SERVICE BULLETIN

T I T L E : AIR CONDITIONING - IMPROVE AIRFLOW AT CABIN OUTLETS

Herewith Revision No. 4 of Service Bulletin A320-21-1020.

SERVICE BULLETIN No. : A320-21-1020

Modification of Restrictors between FR24 and FR34 Figure 5

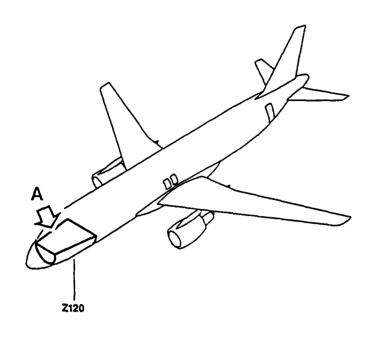
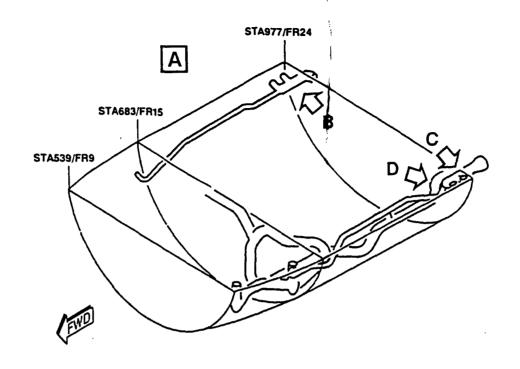
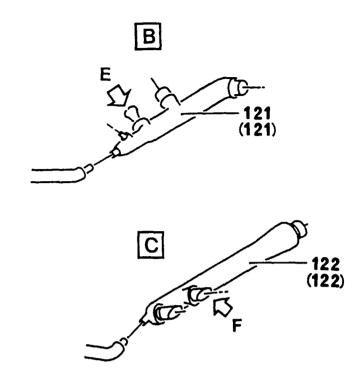
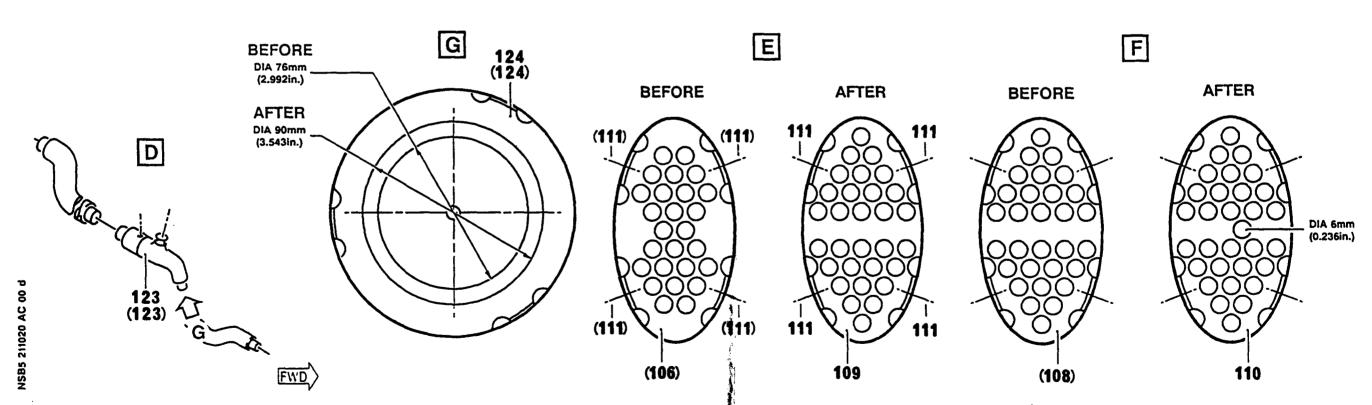
- Restrictor, item 108, detail changed

- (a) Drill out the rivets, item (111) and remove and do not re-use the restrictor, item (106).
- (b) Install the new restrictor D2121096420300, item 108 with rivets ASNA2051DCJ2410, item 111.
- (c) Re-identify the duct to D2121031200500, item 114.
- (7) Modification of the duct D2121032400500, item (115).

- (a) Drill two holes with a dia. of 6 mm (0.236 in.) in the restrictor, item (107) as shown in detail E and re-identify the restrictor to D2121096420300, item 108.
- (b) Re-identify the duct to D2121030600400, item 120.
- (13) Modification of the duct D2121061400400, item (121).
